ECO-SITE, INC. CERTIFICATE OF ENVIRONMENTAL COMPATIBILITY AND PUBLIC NEED FOR THE CONSTRUCTION, MAINTENANCE, AND OPERATION OF A TELECOMMUNICATIONS FACILITY LOCATED AT 63 WOODLAND STREET, GLASTONBURY, CONNECTICUT. DOCKET NO. 478

November 30, 2018

# RESPONSES TO SITING COUNCIL DEVELOPMENT and MANAGEMENT PLAN INTERROGATORIES

GLASTONBURY CT-0007A 63-80 WOODLAND STREET GLASTONBURY, CT 06073 **GENERATOR DETAILS**

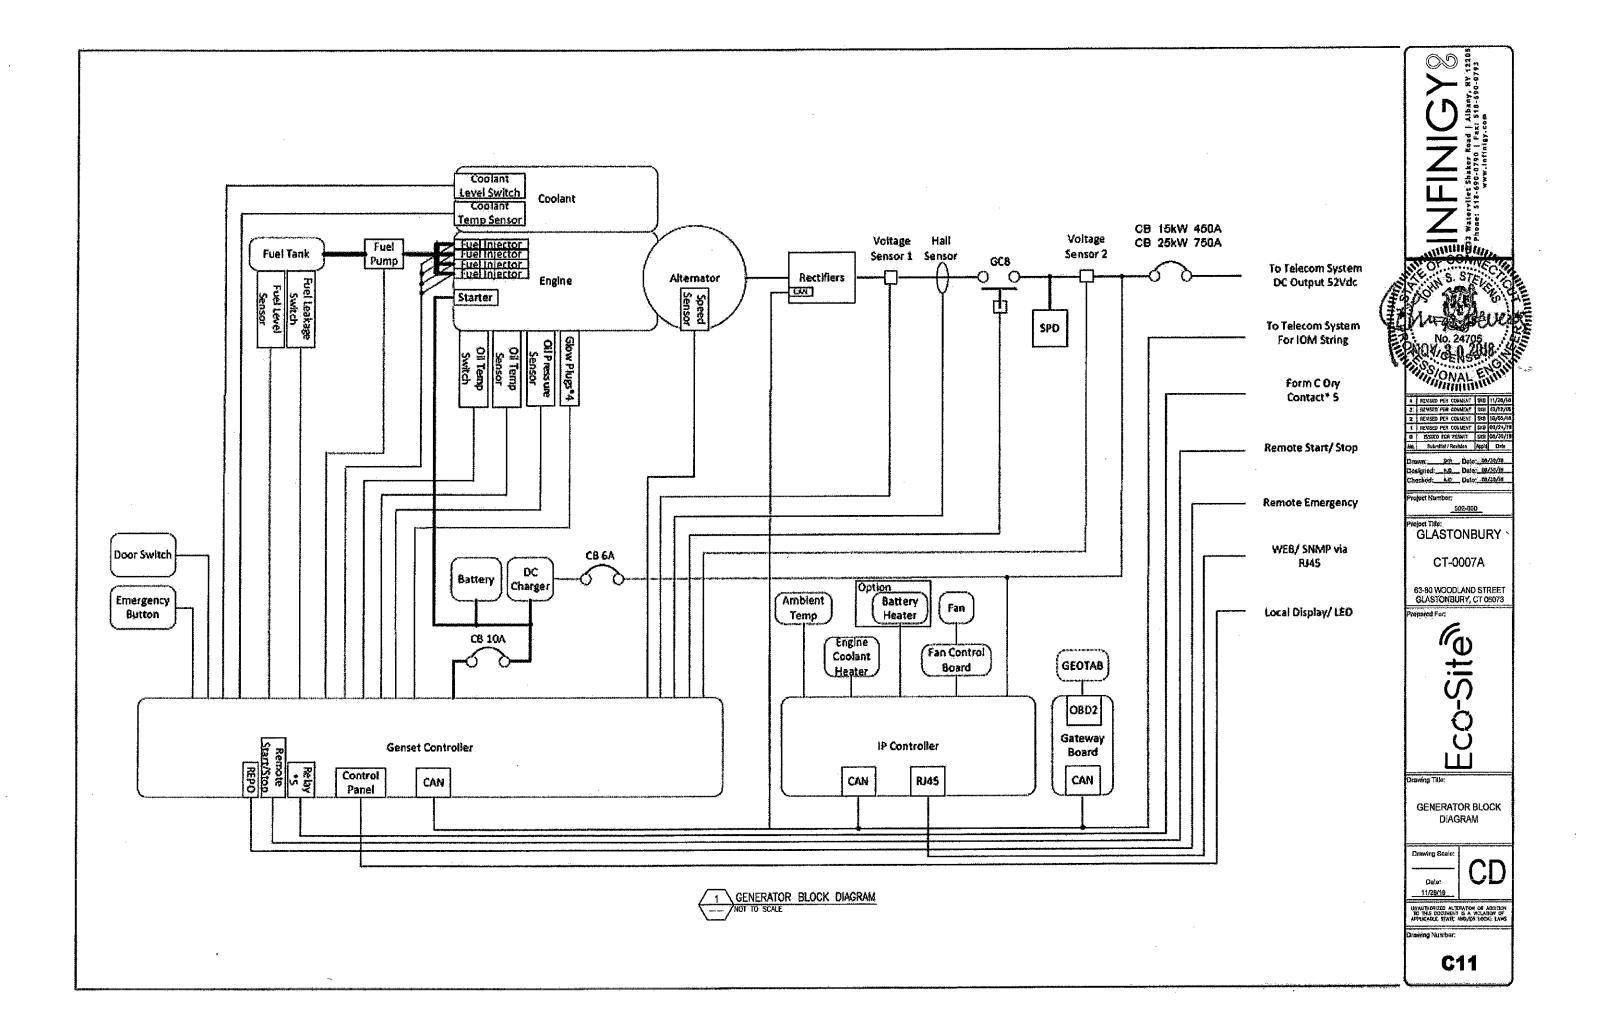
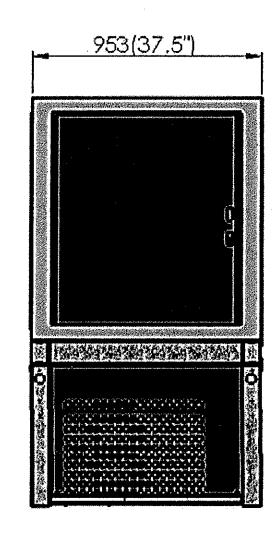
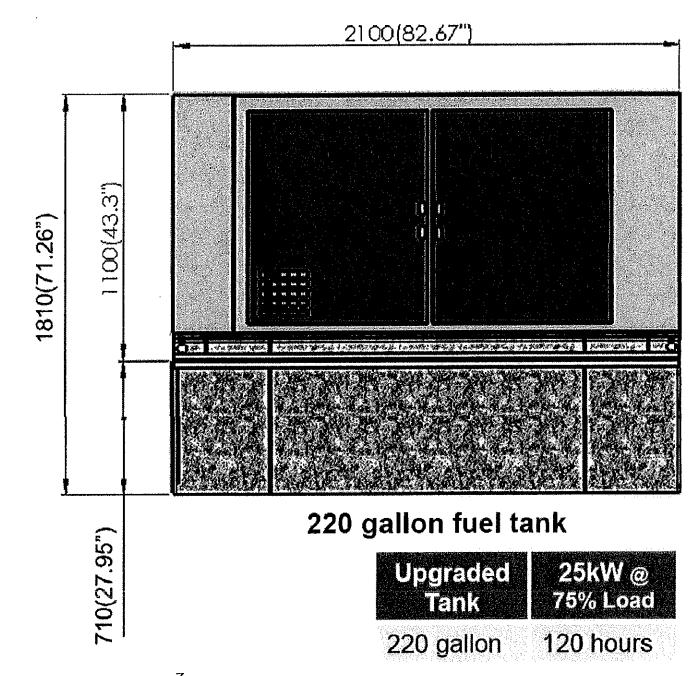
- Q9. The emergency generator specified is different than what was initially contemplated. Is the emergency generator for shared-use? If so, how many carriers can be accommodated. What is the fuel source of the generator? Is T-Mobile or EcoSite responsible for maintaining the generator?

- A9. The emergency generator is for T-Mobile's use only. The fuel source for this generator is diesel per T-Mobile's latest standards. Detail 1 on Sheet C12 of the enclosed drawings depicts the dimensional characteristics of this generator.
